DO NOT SCALE THIS DRAWING - USE DIMENSIONS	
	STATE OF ALASKA DEPARTMENT OF TRANSPORTATION AND PUBLIC FACILITIES DIVISION OF HARBOR DESIGN AND CONSTRUCTION	
Ketchikan	Alaska	
<b>BAR HARBOR</b>		
<b>DREDGING</b>		
<b>CHANGE ORDERS #1, 2, 3</b>		
SCALE 1" = 50'	SURVEYED C.P.S.A.	APPROVED
DESIGNED H.M.	DRAWN C.V.	Robert P. Beck
CHECKED	DATE 6-7-82	CHIEF OF DESIGN
PROJECT NUMBER K-93153	SHEET 1 OF 1

STAMP		DO NOT SCALE THIS DRAWING - USE DIMENSIONS	
		STATE OF ALASKA DEPARTMENT OF TRANSPORTATION AND PUBLIC FACILITIES HARBOR DESIGN AND CONSTRUCTION	
		KETCHIKAN ALASKA <b>DREDGE &amp; FILL SITE PLAN</b> W/ TYPICAL X-SECTIONS	
SCALE <i>As Noted</i>	SURVEYED _____	APPROVED	
DESIGNED <i>CB</i>	DRAWN <i>CB</i>		
CHECKED _____	DATE <i>11-10-81</i>		
PROJECT NUMBER <i>K 93153</i>	SHEET <b>3</b> OF <b>3</b>

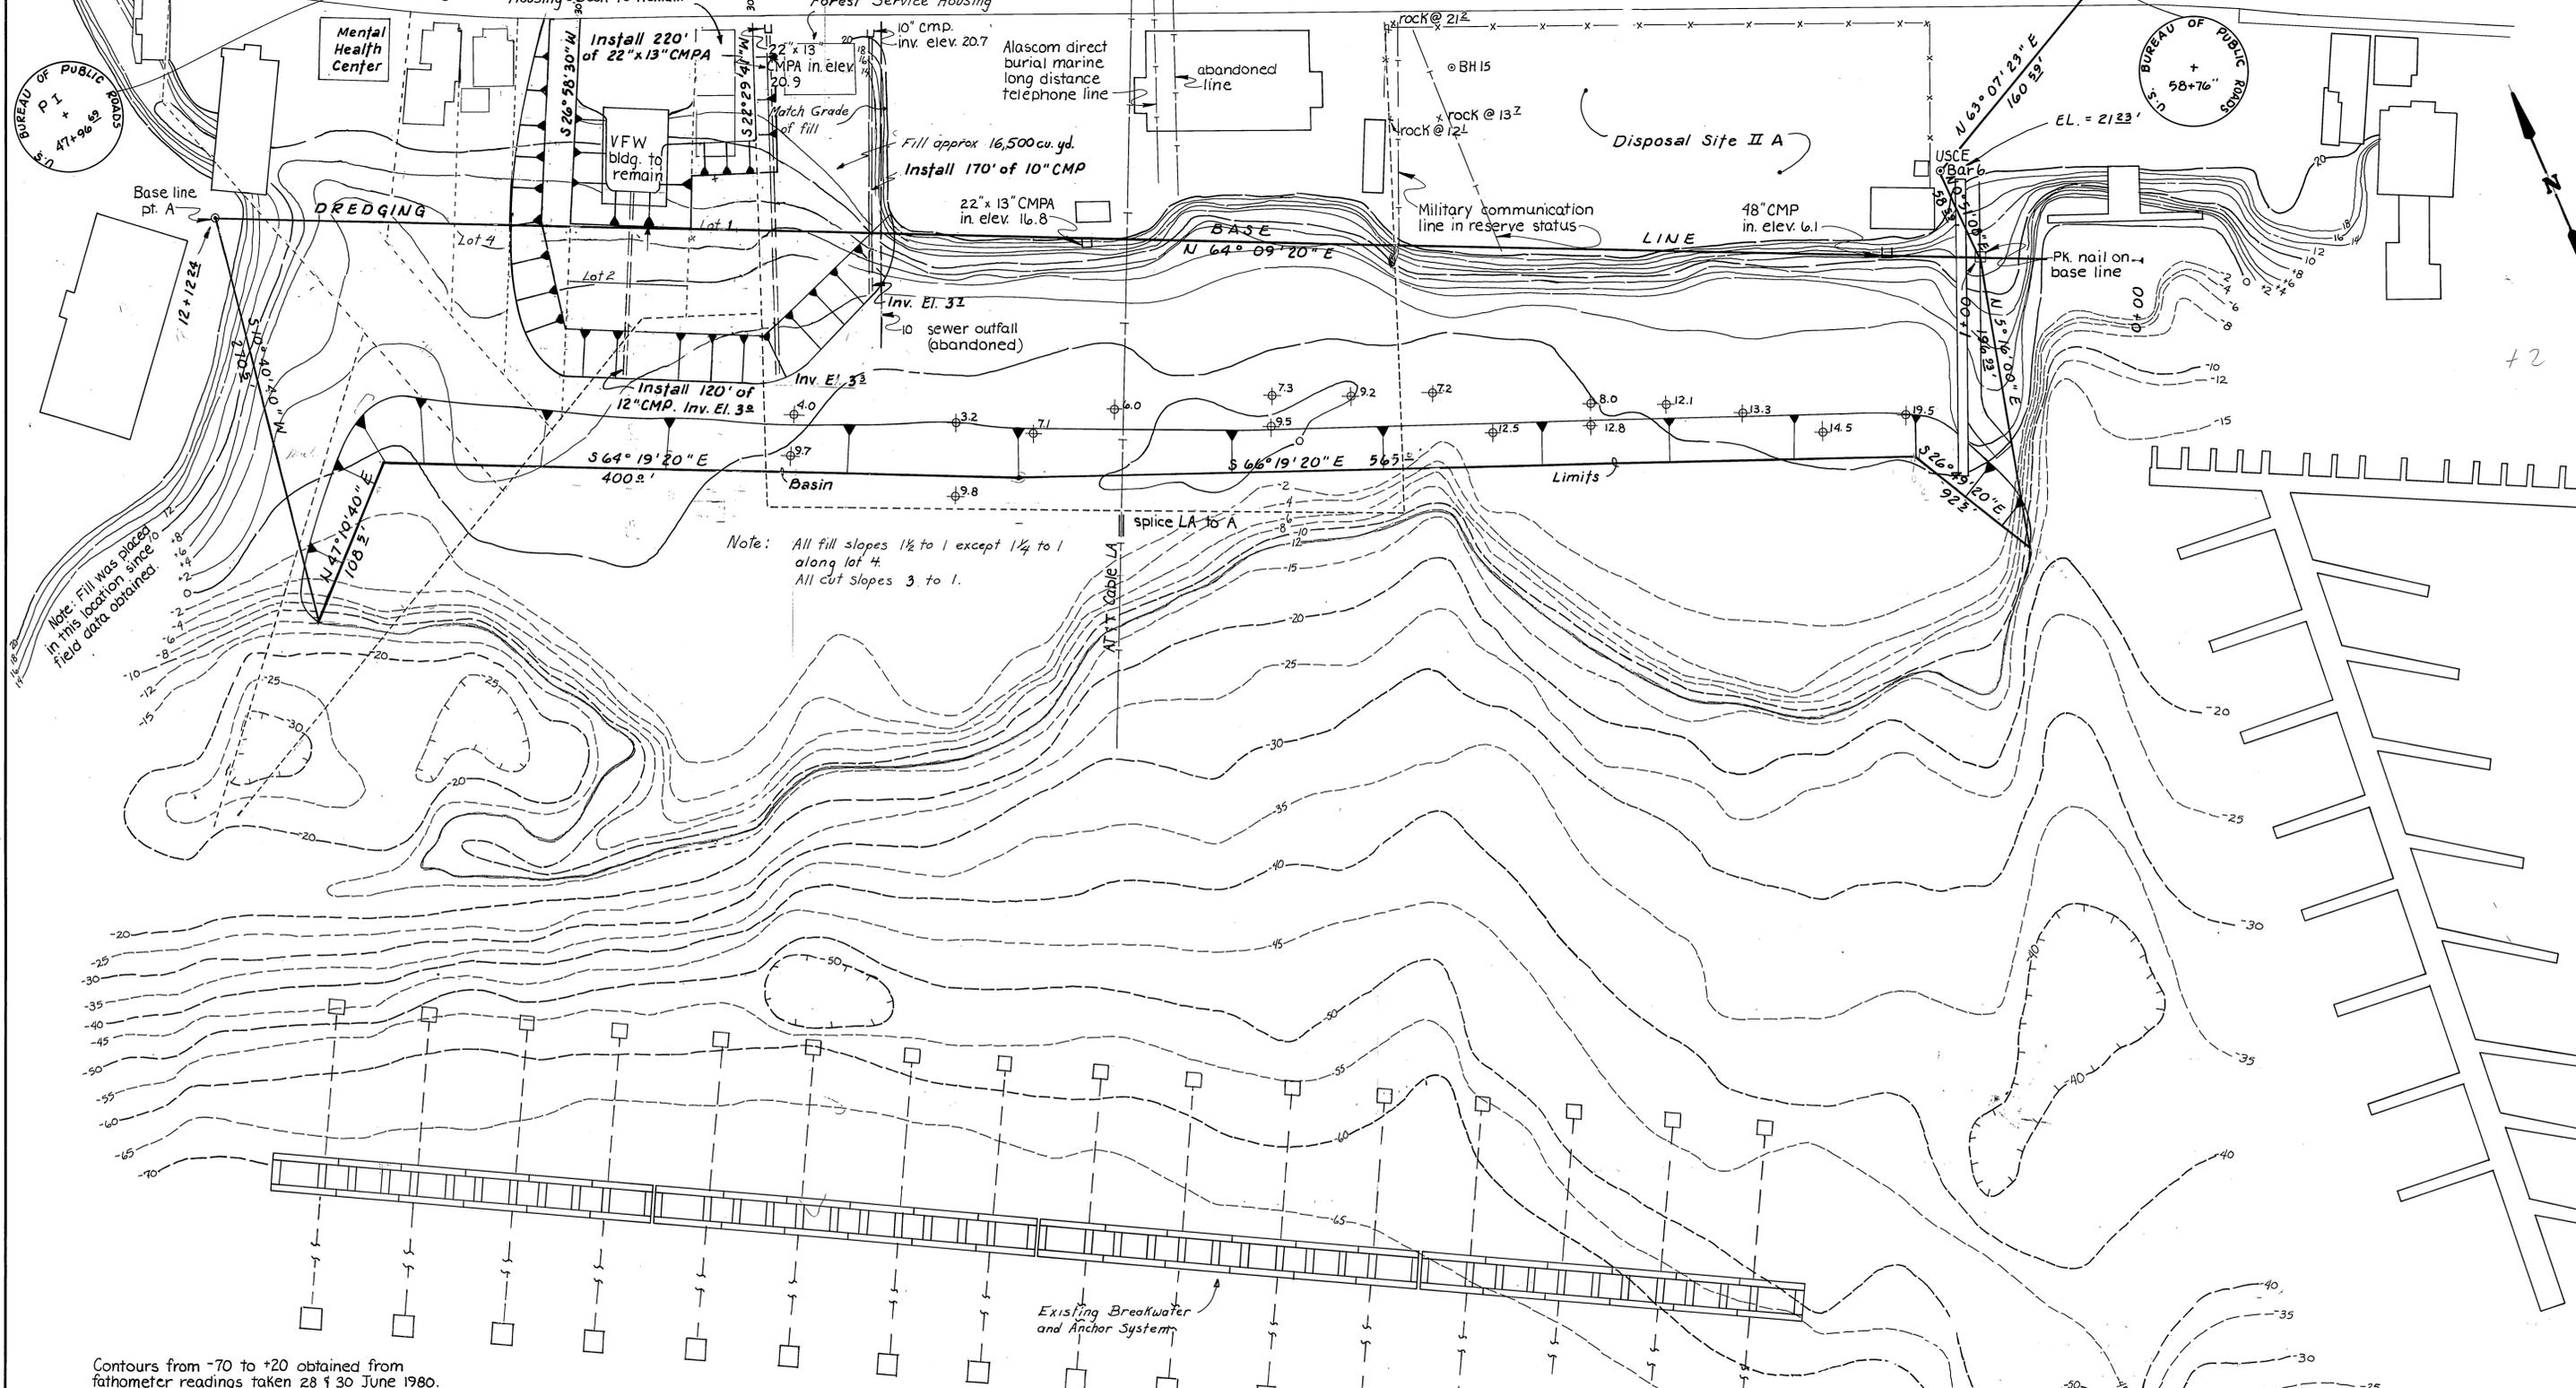
- Work Change Order #3**  
1. Haul excess dredged material from project site. Material to become property of contractor.  
2. Extend uplands as shown, fill material to be quarry spalls.  
3. Slope protection per Change Order #2.
- Change Order #2**  
1. Install 200' - 22" x 13" C.M.P.A.
- Change Order #1**  
1. Delete disposal sites II A, B, C  
2. Dispose of Fill as shown.  
3. Increase quantity of Armor by approx. 1230 yd.<sup>3</sup>  
4. Extend two culverts as req'd.  
5. Delete requirement for Filter Fabric and Filter at Bar Harbor disposal area only.
